## Response to Spokes'

NDDG Fortnightly Meeting  
April 17 2019  
James Sinclair, LHEP

# Questions from the Spokes

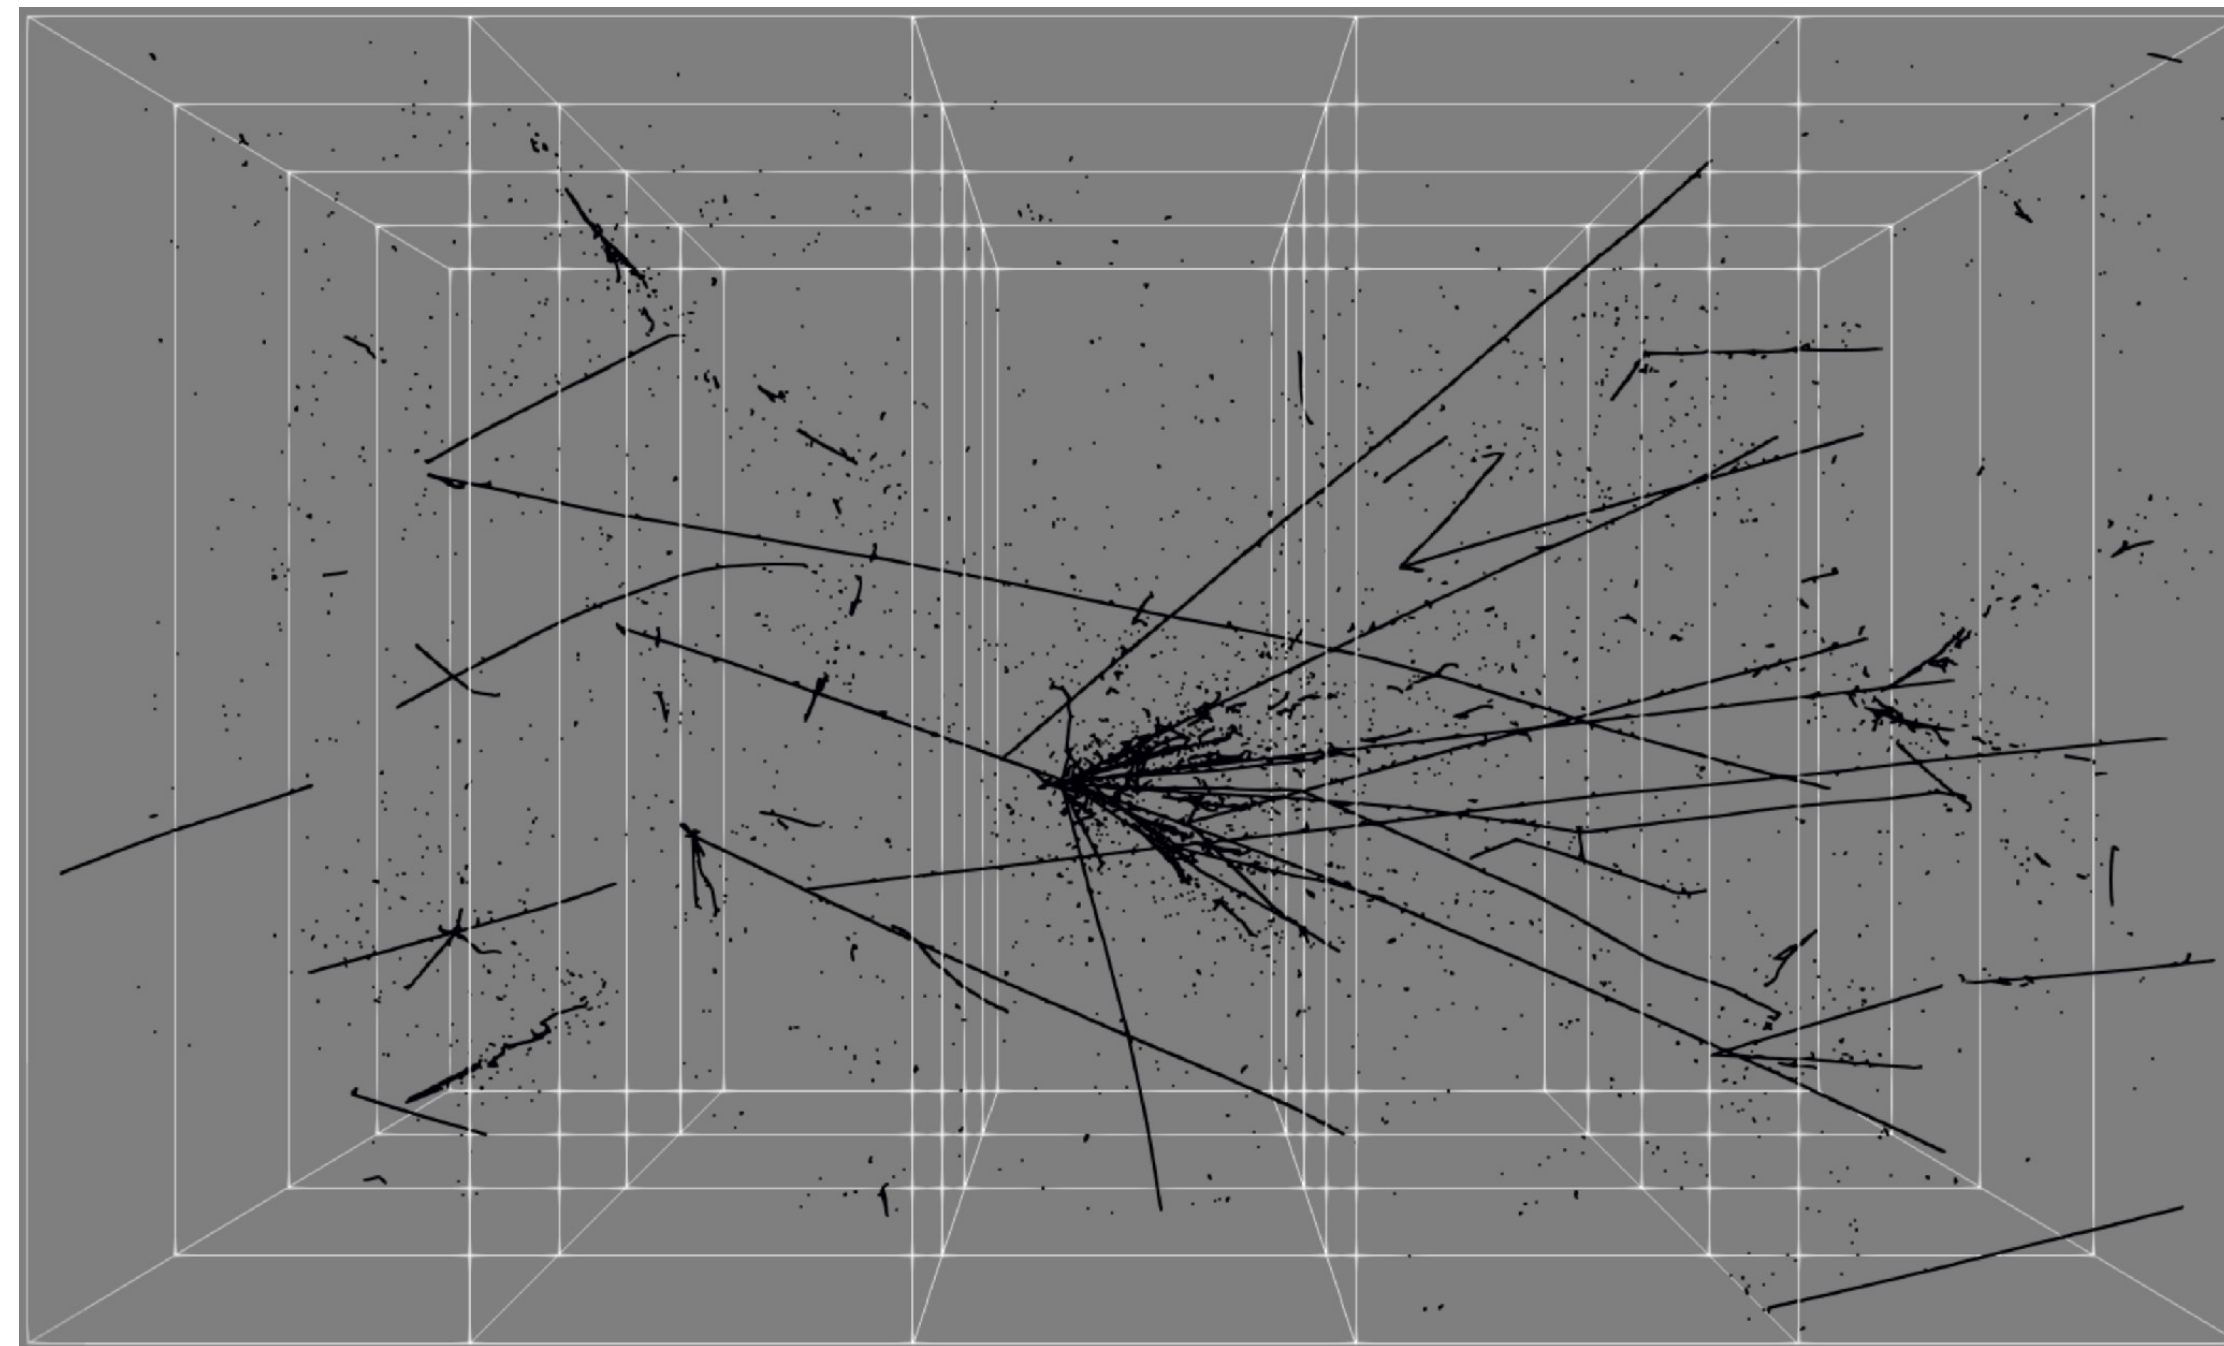
Module dimensions (foot print) are set to simplify reconstruction, through unambiguous light and charge readout.

Diffusion must be much less than pixel pitch (3 mm). Readout window (drift time) must be short to minimise pileup.

13 cm<sup>2</sup>/s diffusion at 1 kV/cm, 50 cm drift length give readout window of 250 us and transverse diffusion of 0.8 mm.

# Reducing Overall Detector Dimensions

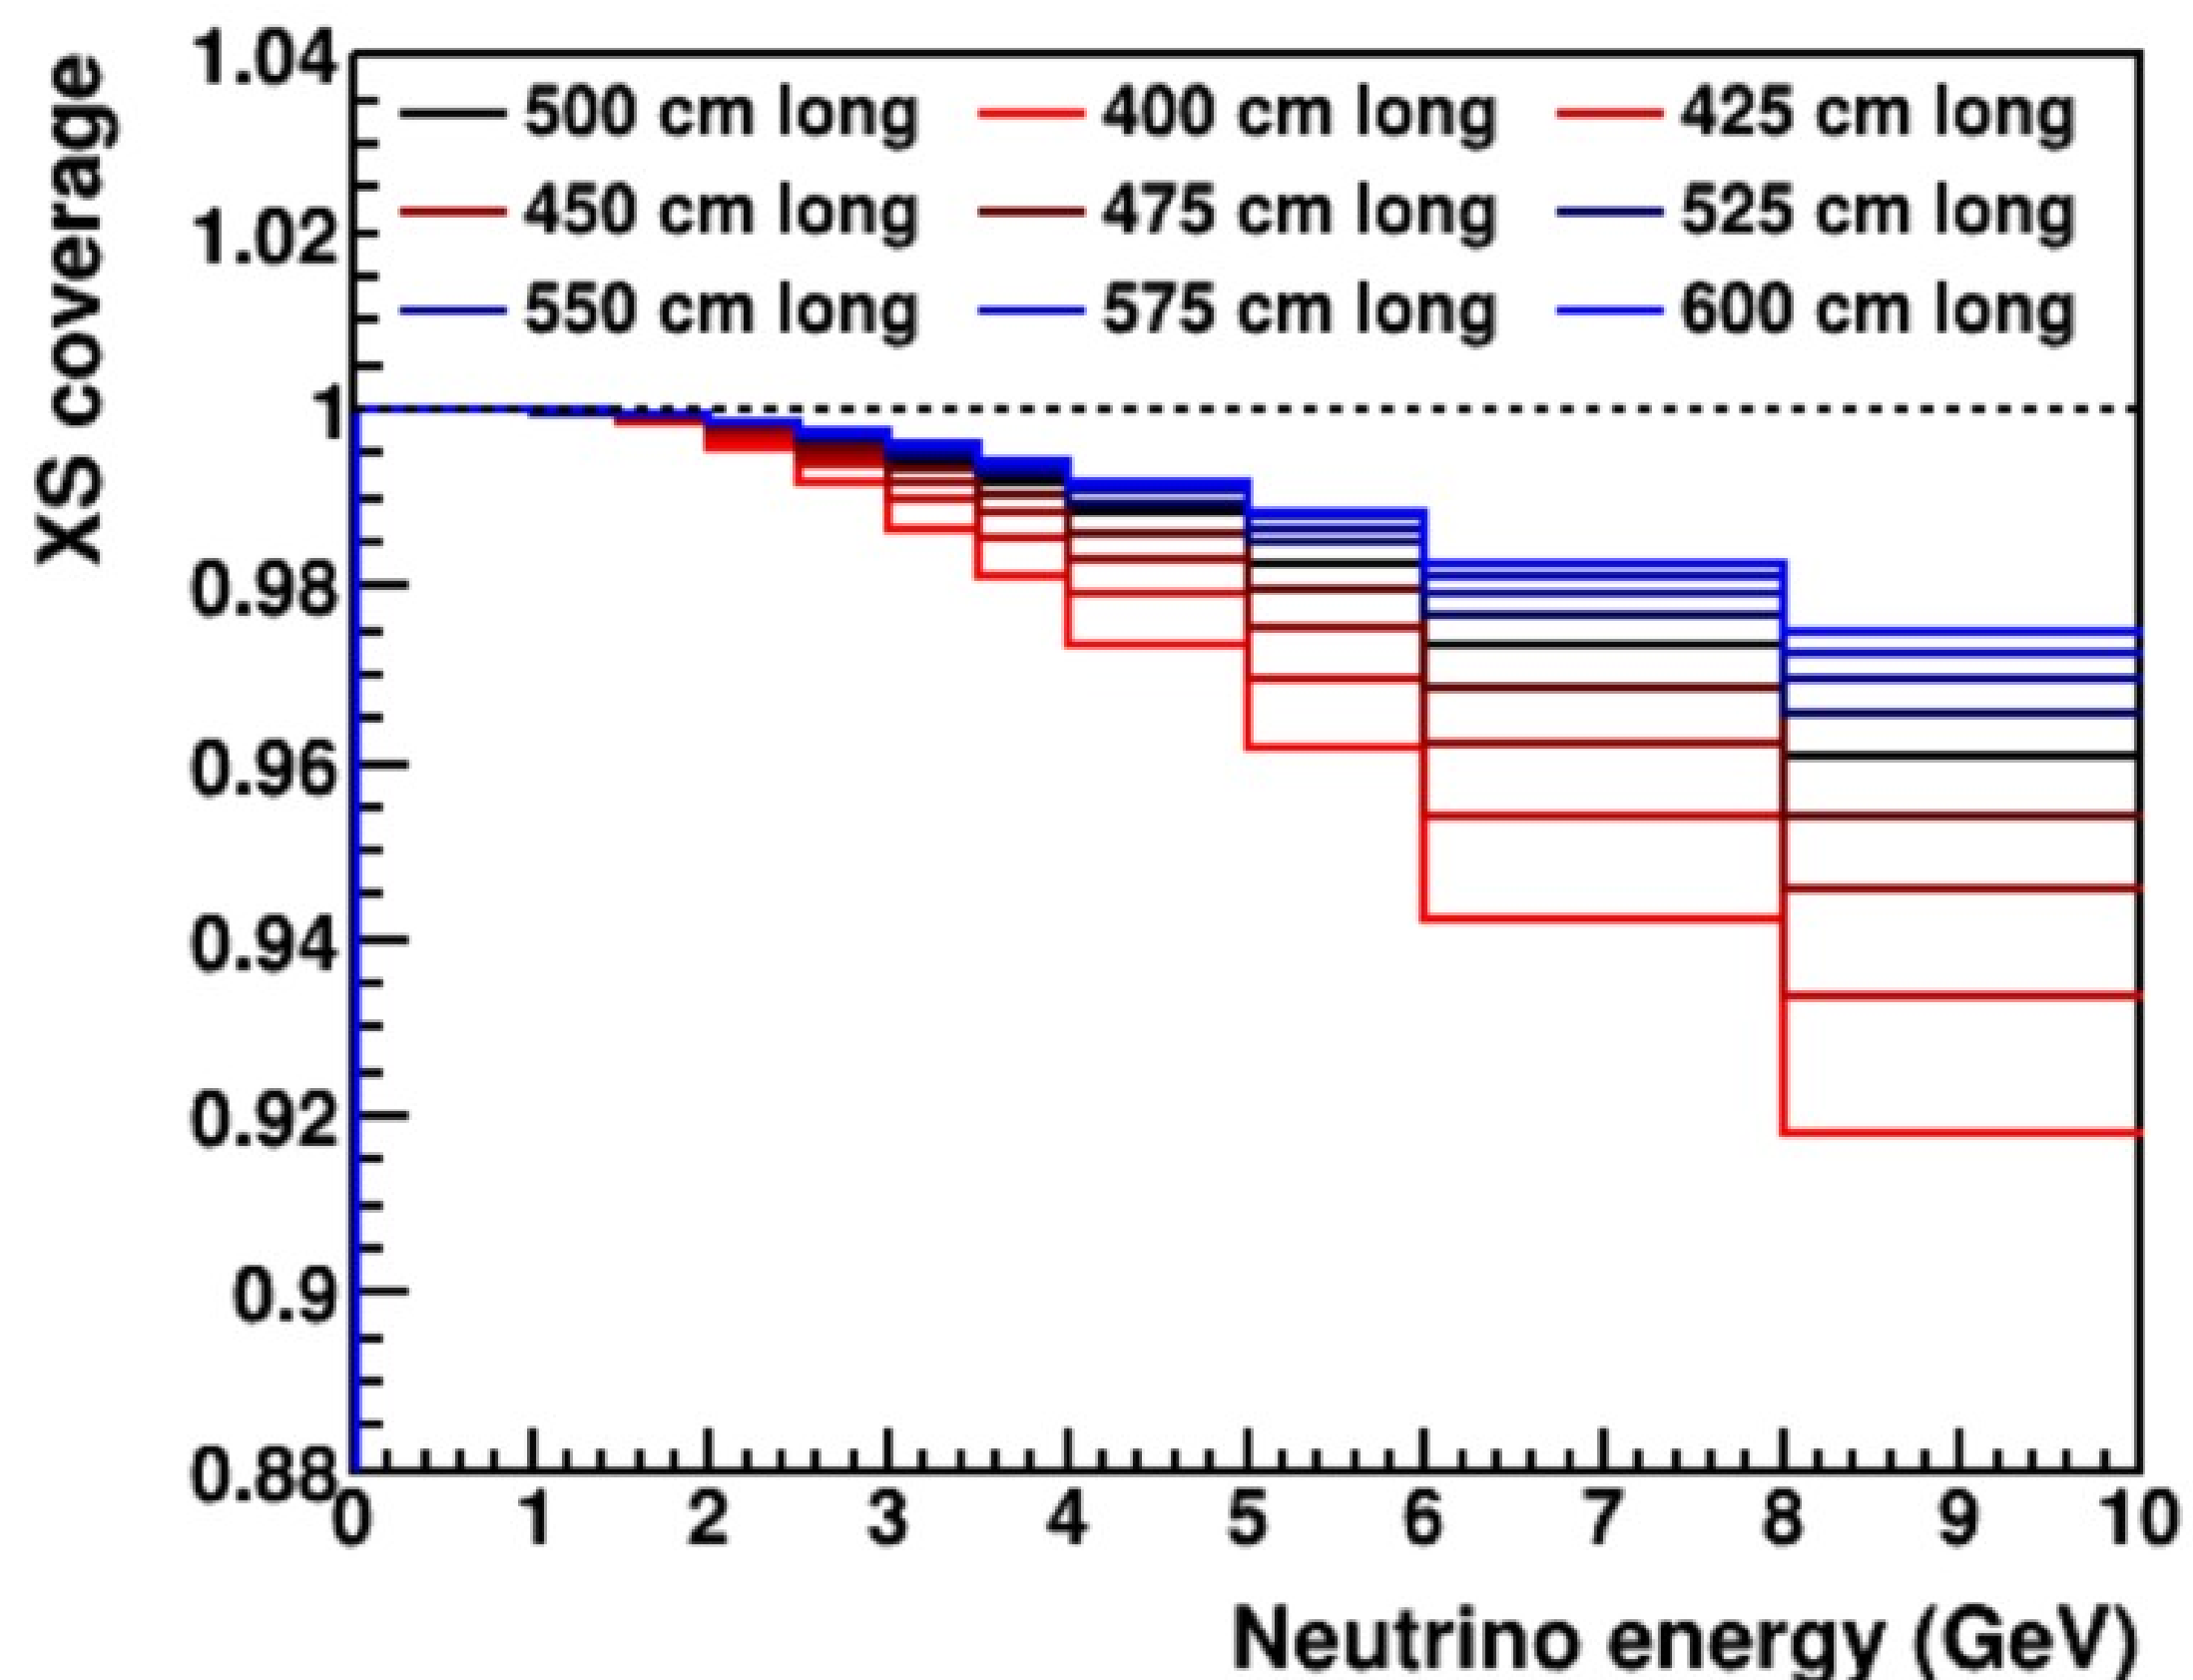
Detector dimensions set by need to measure hadronic showers directly to avoid reliance on models to correct for unobserved energy, across a wide range of neutrino interaction kinematics. [See Chris' last talk DUNE-doc-13133-v1](#)

The optimal size is 4 m wide, 3 m tall, and 5 m in the beam direction.

A fiducial volume can be defined to exclude 50 cm around the sides of the detector and 150 cm from the downstream end, in which the acceptance does not change rapidly as a function of hadronic energy, or position of the interaction vertex.
